# ADA Compliance Program

## Clark County Facilities Transition Plan

### Franklin Building

**Date of Survey: July 10, 2006**

Fig. 307.2  
Limits of Protruding Objects

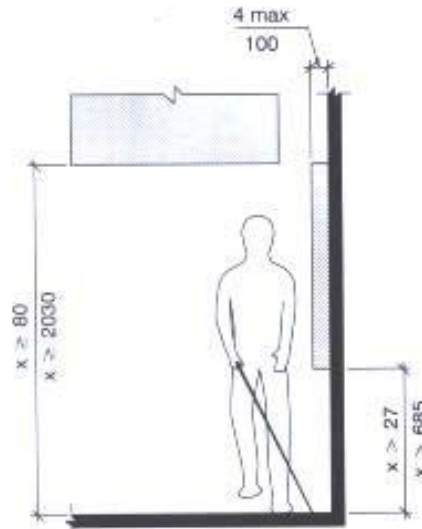
**Item:** Drinking Fountain – 1<sup>st</sup> Floor Lobby – Protrusion Limits

ANSI 307.2 Protrusion Limits. Objects with leading edges more than 27 inches and not more than 80 inches above the floor shall protrude 4 inches maximum horizontally into the circulation path. The drinking fountain shown protrudes significantly into the hallway and the height exceeds the 27 inch minimum.

The fountain should be recessed into an alcove or protected by cane detectible barriers.
